ATTACHMENT A
NPS COMMENT RESPONSES
WITH EXTENDED NARRATIVES
MARCH 31, 2017

The Utah Division of Water Resources (UDWRe) appreciates the efforts of NPS in participating in the LPP (FERC Project No. 12966) Integrated Licensing Process (ILP) to date. UDWRe is committed to working with NPS and other agencies with land management and/or regulatory responsibilities in fulfilling their obligations in this licensing proceeding. On September 9, 2016 UDWRe received 115 comments from NPS on the Final License Application (FLA) submittal. As discussed in the meeting with NPS on February 1, 2017 in Page, UDWRe is committed to assisting NPS in fulfilling the information needs to help complete the regulatory processes leading for approving the LPP and associated rights-of-way on NPS-administered land. All 115 comments have been assigned an identification number entered into where complete responses are provided for most comments. For those comments that require longer responses or include more extensive revisions to the licensing documents, UDWRe provides those responses in this Extended Narrative document. Responses with **bold** text represent actual revisions made to the License Application fi

UDWRe Figure 3-8a MWH

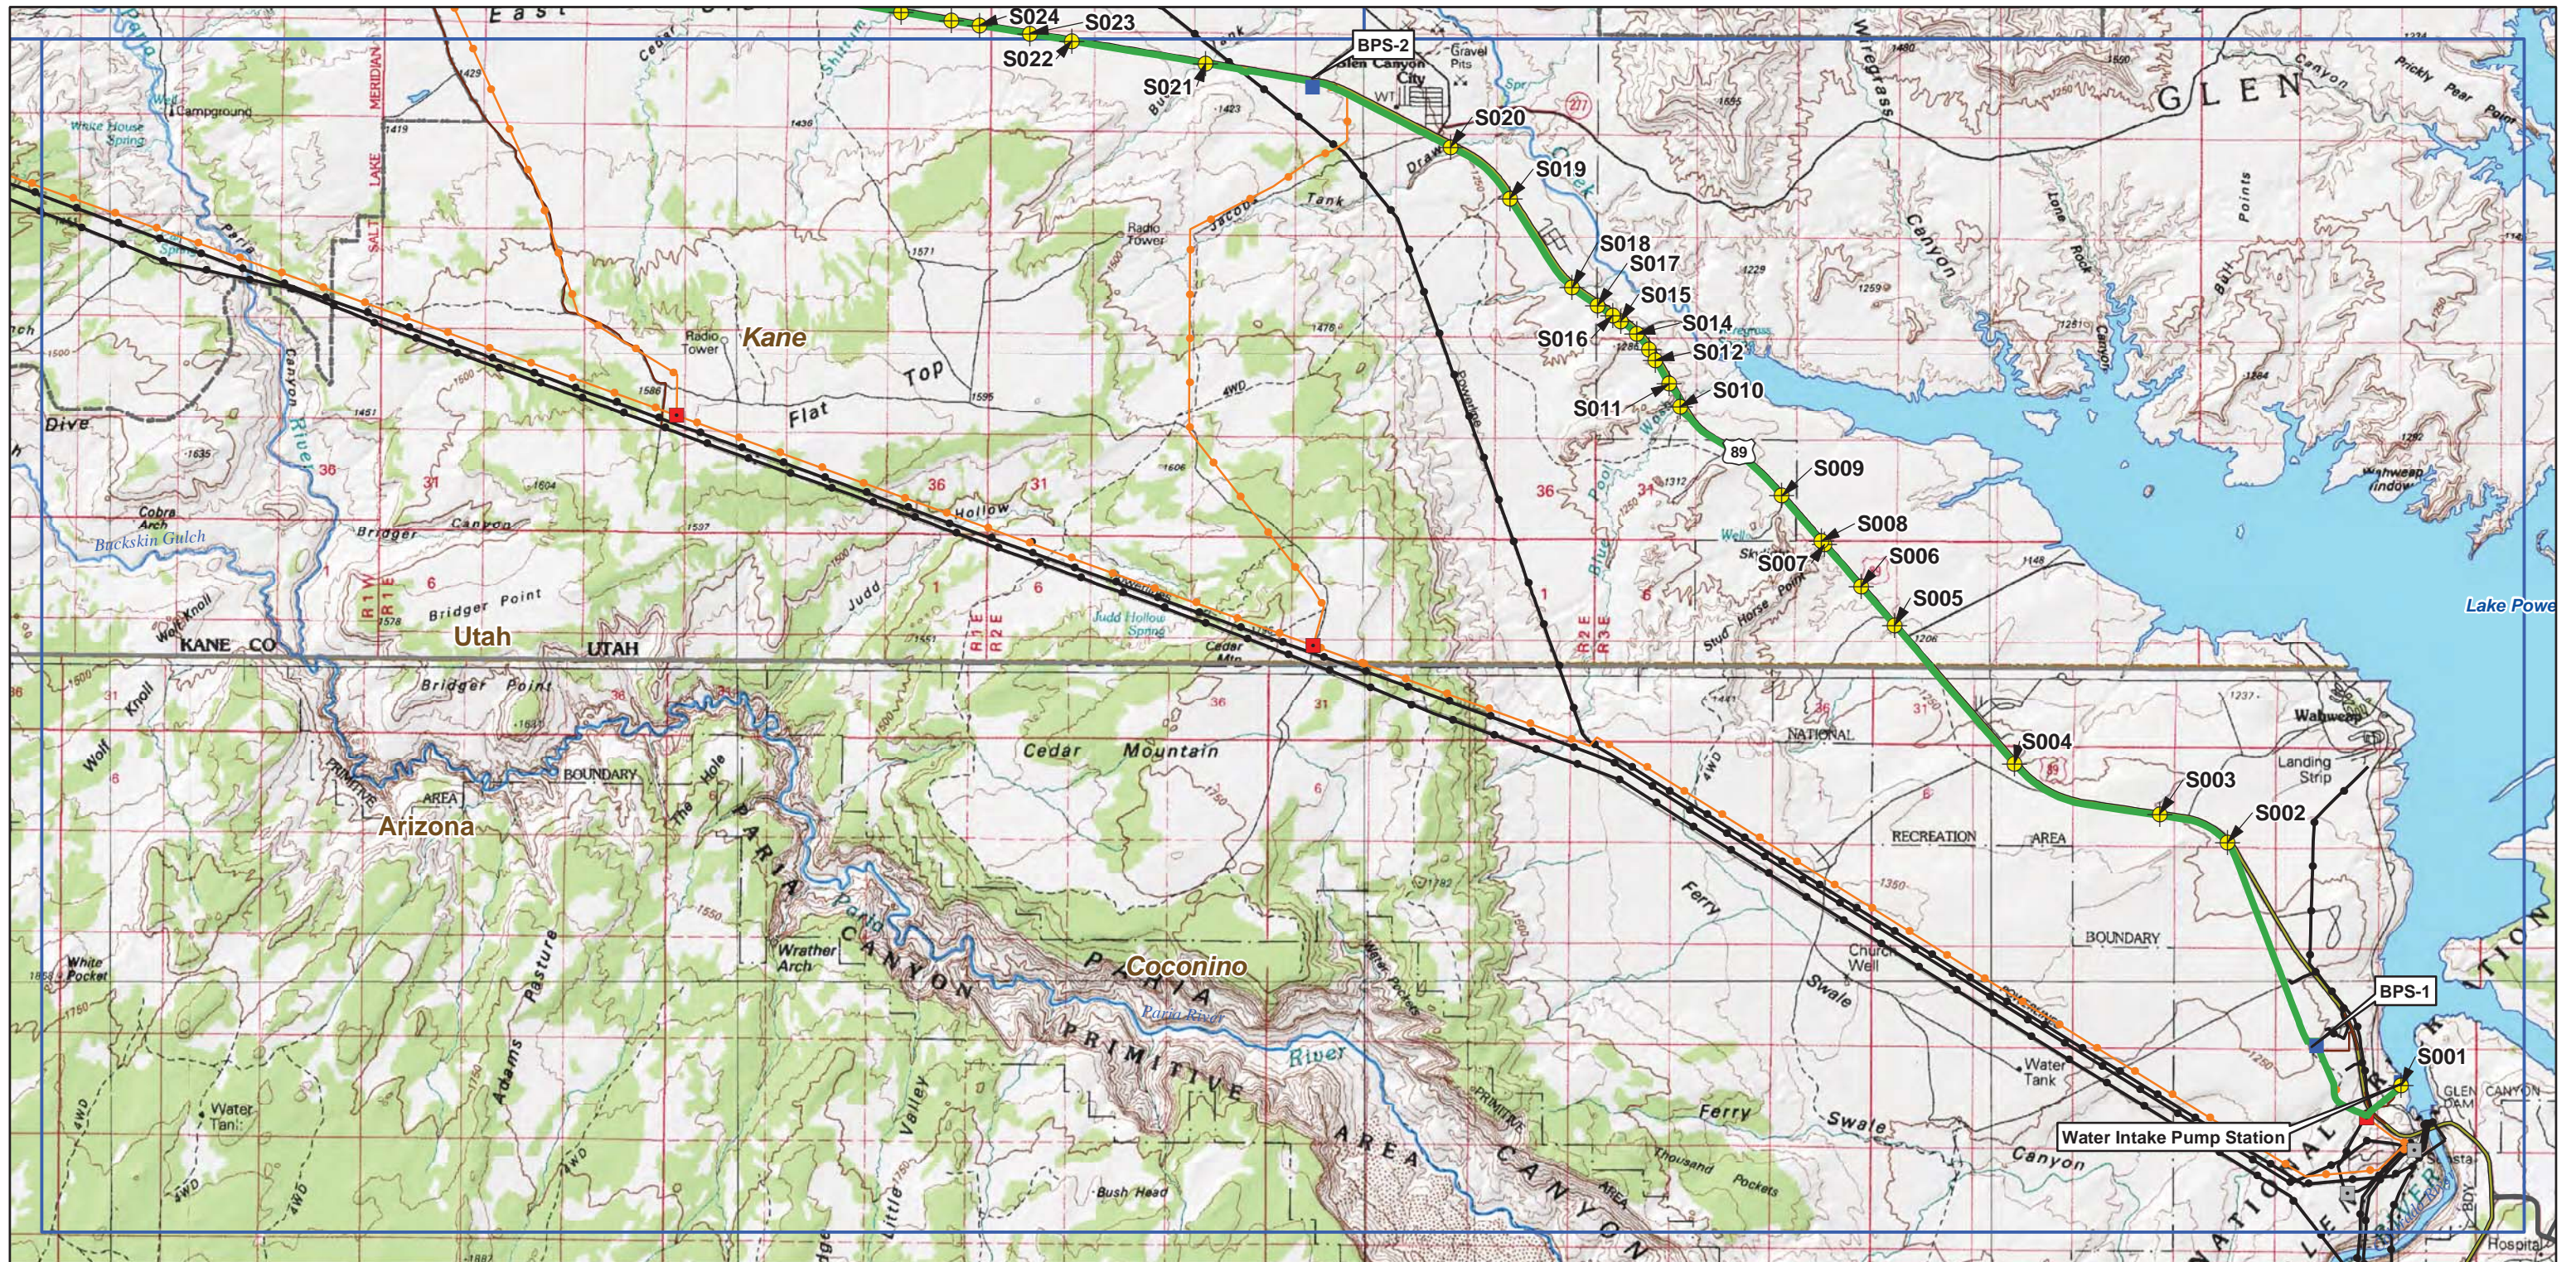
NPS Comment No. 13

(Figure 3-8a responds to NPS Comment No. 13)

Location information for the proposed route to BPS-1 is provided and the text is updated with additional information on and analysis of molluscicide use.

Location information for the proposed BPS-1 access road on NPS-administered land in GLCA is shown in Appendix E, Map Panel 01 in Exhibit E of the License Application. A portion of the proposed access road is shown in Figure 3-8 in Section 3.1.1.2.2, Chapter 3, Exhibit E of the License Application. The access road is adjacent to the existing Arizona Department of Transportation maintenance facility. Figure 3-8a (attached as a PDF file to this response) shows detailed location information for the entire alignment of the proposed BPS-1 access road on NPS-administered land in GLCA. No cultural resource sites are recorded or found along the proposed BPS-1 access road. Two individual plants of the special status species *Phacelia mammalariensis* (GLCA G2 species) were identified within the proposed BPS-1 access road alignment study area. Please see Section 5.3, Exhibit E of the License Application for details on affected environment and environmental effects analyses for resources on NPS-administered land in GLCA. Chapter 5, Exhibit E and Final Study Reports include site-specific studies and analyses performed and documented for special status plant species, special status wildlife species, vegetation communities, wildlife resources, noise, air quality, visual resources, land use, geology and soil resources, paleontological resources, and cultural resources.
